GHD cross-sections v2 for Steering Committee meeting on 24th Oct

Cross Section & Case Study Review Memorandum

To	Shelley Bennett (CoPP), Alex Robinson (CoM)		
Copy to	Theodora Hogan (Melbourne Water), Todd Berry (DELWP)		
From	David Howard	Tel	+61 3 8687 8789
Subject	Fishermans Bend Streetscape Case Study Review	Job no.	3136555

Fishermans Bend Drainage Strategy – Case Study Review

SECTION A
LOCAL STREET ADJACENT
TO OPEN SPACE.

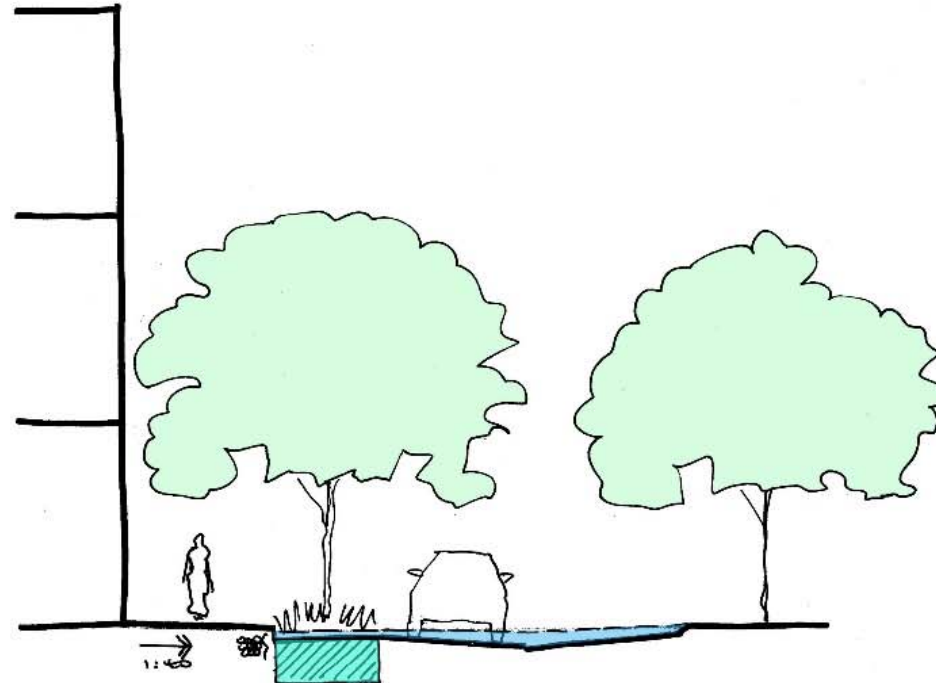
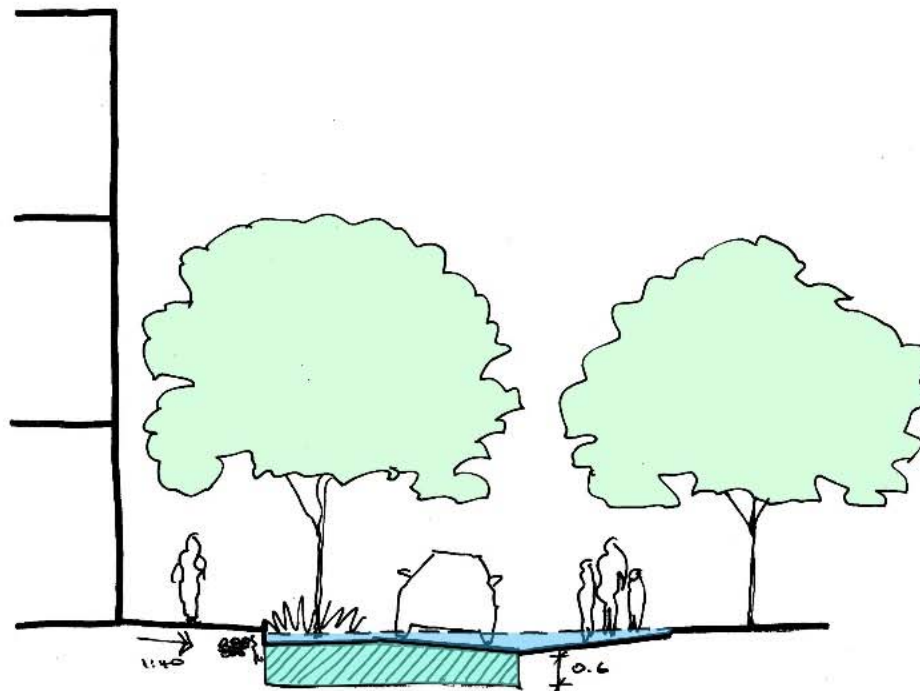
Section A should provide some level of detention (0.6 sq m as per Ramboll blue lane way detention interpretation). Further collaborative work is required here.

SECTION A
 LOCAL STREET ADJACENT
 TO OPEN SPACE.
 ADDITIONAL STORAGE
 OPTION.

SECTION B
 LOCAL STREET W
 LINEAR PARK.

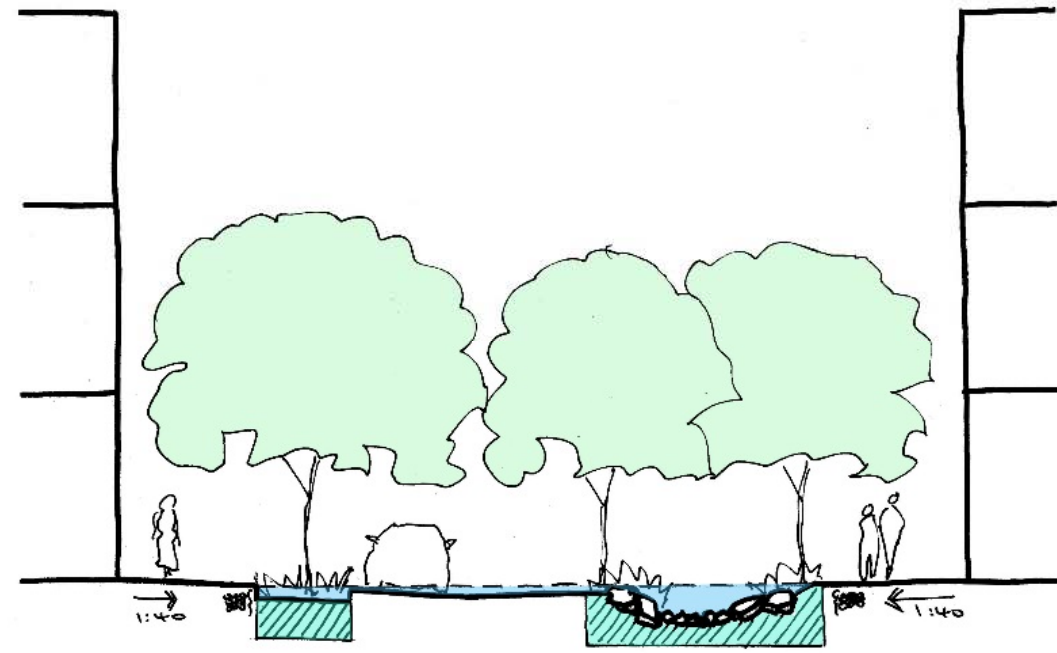
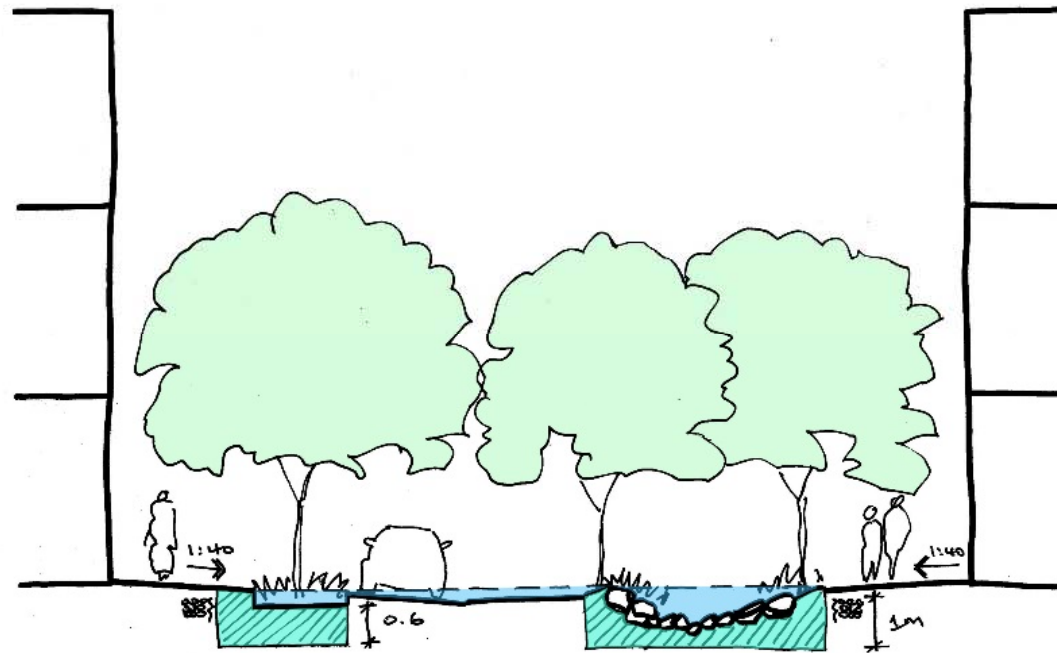
SECTION B
 LOCAL STREET W/
 LINEAR PARK.
 ADDITIONAL
 STORAGE
 OPTION.
